PHOTOGRAPHS

BUILDING 7 SECTION A

PHOTOGRAPH #7

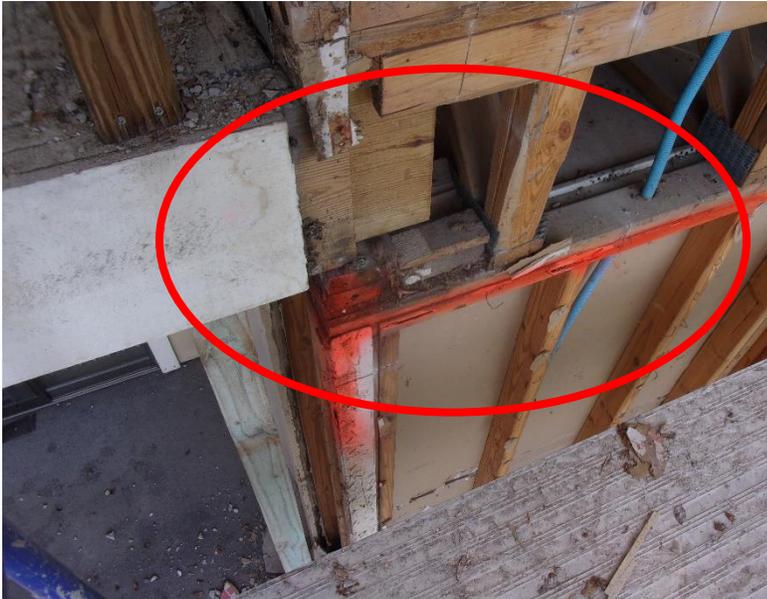
Delta inspected wood framing conditions and marked for repairs.
